## PROCESS CHANGE NOTIFICATION PCN0902

### ADDITIONAL ASSEMBLY SOURCE AND BILL OF MATERIAL CHANGE FOR ALTERA FLIP CHIP PRODUCTS

**Figure 2. Comparative top side images of the current lid and new single piece lid**

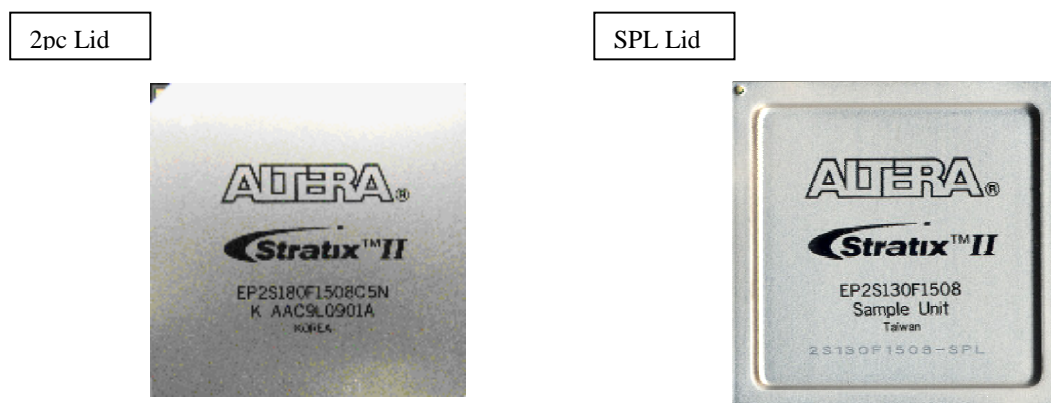
This change does not affect the fit or function of the devices. There is a slight appearance change to the form due to the conversion from a two-piece to a single-piece lid. There is no change in the current moisture sensitivity rating levels (per JEDEC J-STD-020D) or the thermal performance. The package dimensions are the same. Both the single-piece and the two-piece lids are constructed using the same Ni plated Cu materials.

Customers may want to review their existing heatsink application for compatibility with the new SPL design. Both the additional assembly site and the construction material set change have been verified through the successful completion of full qualification. Supporting reliability data are included in this notification.
